Wiltshire Council Planning Consultation Response URBAN DESIGN

Application No: PL/2023/10495

Application: Conversion of Elmfield House and outbuildings to 6 x dwellings and the erection of 15 dwellings, hard and soft landscaping and associated works

Site Address: Elmfield House, Petersfinger.

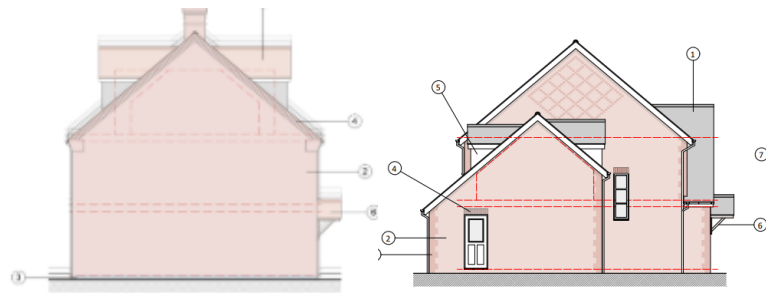
- 1) Plots 13/14/15: (drawing 963.07 C 'Proposed Site Plan and 963.189 Rev C Plots 13/14/15 Plans & Elevations')
 - a) The proposed expanse of hardstanding and run of car parking bays over this forward of the houses, and removing the hedge/walled boundary and garden frontage to the lane which is a key component of the intrinsic rural character of Petersfinger Road, would introduce a distinctly urban character into this setting, and compounded by the existing garaging and forecourt opposite, a car dominated street scene. This would not enhance but significantly diminish the essentially rural quality of the lane that it would be desirable to maintain. It would be reasonable therefore to expect only a single vehicle width access as with the existing gated boundary here, should therefore be maintained.

- b) The combined roof span, depth and height of the terrace shown to achieve a significant attic second floor, in proximity to the lane would be of a singular mass that would appear visually awkward (cumbersome) appreciated with the neighbouring properties along the lane, including its relatively uniform form and appearance which also imparts a typically urban estate housing character in juxtaposition with the comparable greater degree of articulation of building form and roofscape of the grouping of Elmfield House /Yew Tree cottage alongside.

X Point 1 a and 1b - Not satisfactorily addressed . On revised Proposed Site Plan 936.07 Rev J, the proposed semi-detached pair in place of the previously proposed 3 houses in a terrace, would address the above, including the reduced overall scale (height and mass) in juxtaposition to Elmfield House and other neighbouring dwellings, apart from, the loss of

characteristic existing mid height walled /hedge backed boundary to the lane, which appears to be shown on Proposed Site Plan and Landscape plan as open plan lawned frontage between and either side of the two proposed driveway access and to the return side of drive to house 13 facing the A36. Also, without the building line set well further forward this could result in front garden later being given up to vehicle hardstanding /bays across the face of the houses furthering an urban character.

X The existing brick site boundary prominent on the approach along the A36 is also a particular characteristic feature notably attractive for its long curved line and capping . This is not identified as being retained on the previous or current revised Plans (extracts above) drawings but replaced by a 1.8m high timber fence to the garage sideways and intermittent planting in the relatively narrow margin revealing the driveway / parked vehicles . Existing trees following the A36 alongside plot 13 are shown removed. The domestic or acoustic timber fence would be prominent in this street scene and would not maintain the lasting or quality of appearance of the existing brick 'county estate wall'. This wall should be maintained and could be extended with hedge / tall shrub planting behind it to provide some possible obscuration of the largely blank side elevation of proposed house 13.

- c) The large side /end of terrace elevation of house 13 is shown blank and in this essentially street corner position would be visibly austere from the lane and A36(T) in proximity. Existing or proposed vegetation forward of this would do little to moderate this and may be cut back , die back or be removed at any time and cannot be practically ensured by planning condition). This would not accord with CP57 iii (elevational design). This would represent in principle BfHL page 54/55 'what red looks like' photos and third and eighth bullet points whereas 'what green looks like' pages 52/53 photos of dual aspect homes with significant windows on outward facing side elevation serving 'habitable 'rooms' (i.e. not a toilet or bathroom or small obscured glazed opening) .

Placing a garage /attic storey now proposed in place of the two storey side elevation previously shown on this line, would be an improvement by setting the two storey element further back from the A36 frontage. This would reduce the visually poor street scene setting of essentially blank side façade in approach view along A36 seen above 1.8m high timber boundary fence to this plot (elevation below right). In relation to my comment above on point 1a and 1b, tree planting is shown on the revised Landscape plan to this relatively narrow margin contained between plot boundary fence / house façade and A36 highway which would appear to be insufficient for significant tree canopy and root spread and whereas in this proximity to such a major highway it is typical for housing to be set back with a significant depth public open space between.

6) The 'dry canal' (drawing 963.07 C 'Proposed Site Plan' and 414 PN 01 Rev B Landscape Plan)

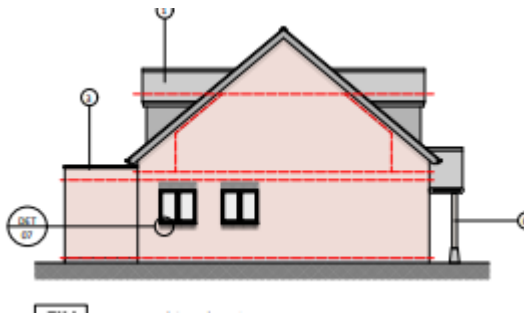
This significant existing strip through the site which appears to be part of the local watercourse and is bordered by existing landscape is now proposed to be sandwiched between and bounded by the enclosed rear gardens of the proposed plots on both sides (whereas in previous 19/00967/OUT & PL/2021/07611REM the proposed density and lesser overall number of houses enabled retaining an appreciable landscape down one side of this which would maintain a landscape context and setting for the watercourse).

Contained by and largely hidden from view by the proposed rear garden fences would leave this strip outside of and not visually contribute to practical residents accessible (public) open space. This includes where the watercourse is shown 'wet' bridged by the road with the high fencing carried up to the bridge edge on both sides which would appear ungainly as a barrier restricting views along the close.

X On the current Landscape Plan 414_PN_01 Rev D the fencing containing the watercourse and carried up to the bridge edge on both sides appears to be denoted as 1.2 m high ?(extract of this revised plan and key annotation below,) but there appears no drawing of the appearance of the bridge over the watercourse i.e. railings to the bridge? and how this would relate to the proposed fencing carried up to the bridge abutments. A 1.8m high fence is still shown down this side forward of house 9 side facade(extract below) and meets this fencing to the watercourse at a visually awkward point. This high fence would reveal a blank first floor facade above this. This collectively would be a visually poor backdrop in the street scene approach along the road. The watercourse is shown enclosed off by the high fence across it and along its length with a 'proposed maintenance access gap ' at its southern end from the A36. (Where it passes under the highway). Is this one access giving directly onto a major highway practical for drawing in/out maintenance equipment /parking up ? For security to deter informal access into this not well overlooked and tightly contained high fenced corridor, high secure locked gates would appear advisable across this.
